TO: City of Madison Plan Commission  
FROM: Timothy Sobota, Transit Planner, Metro Transit  
SUBJECT: 802 East Washington Avenue – Conditional Use – “The Galaxie”

TITLE: 802, 854 East Washington Avenue (800 North Block) – Mixed-Use Development with Commercial (Including a Grocery Store), Office and Residential Components in UDD No. 8. 2<sup>nd</sup> Ald. Dist. (32089)

Attached: Notated copy of Site plan, showing transit information,  
Draft Station Plan View, from Madison Transit Corridor Study Document.

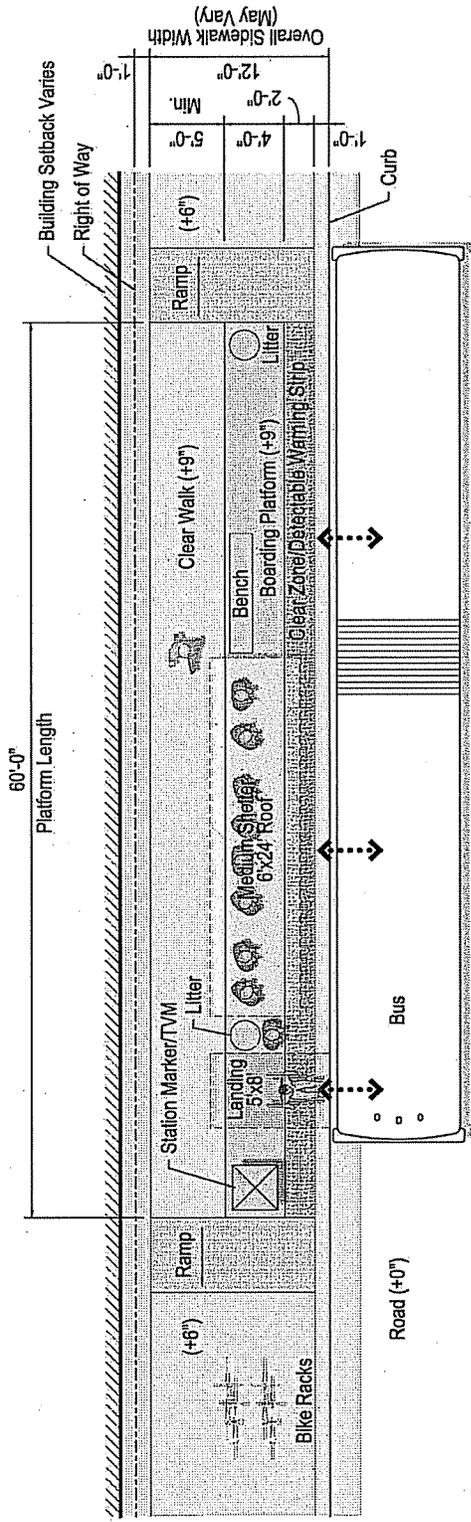
1. In coordination with public works improvements, the applicant shall maintain or replace the concrete passenger boarding pad at the existing Metro bus stop on the north side of East Washington Avenue, west of Paterson Street (#1660). The concrete pad shall occupy the full distance of the terrace, measure a minimum of 10 feet in width parallel to the street, and lie flush between the sidewalk and the top of curb. A continuous concrete terrace would also be suitable.

2. The applicant shall install and maintain a bench or other seating amenity in the adjacent property landscape plan, ideally taking advantage of any building overhang or canopy to provide the seating amenity some shelter from the elements.

3. The applicant shall maintain and protect access to the existing bus stop zone for both pedestrians and transit vehicles at all times during project construction.

6. Conceptual Bus Rapid Transit (BRT) design studies have identified the existing bus stop zone area as a potential BRT station location. Sample BRT station design guidelines indicate at least 12 feet of available right-of-way being typical for the dimension measured from the face of curb across the station platform to the back of a public sidewalk. A minimum of eight feet is shown for just the BRT station infrastructure, measured from the face of curb to the rear point of a passenger shelter structure. City Engineering staff may coordinate right-of-way alignments in this area to accommodate any potential future need for BRT infrastructure.
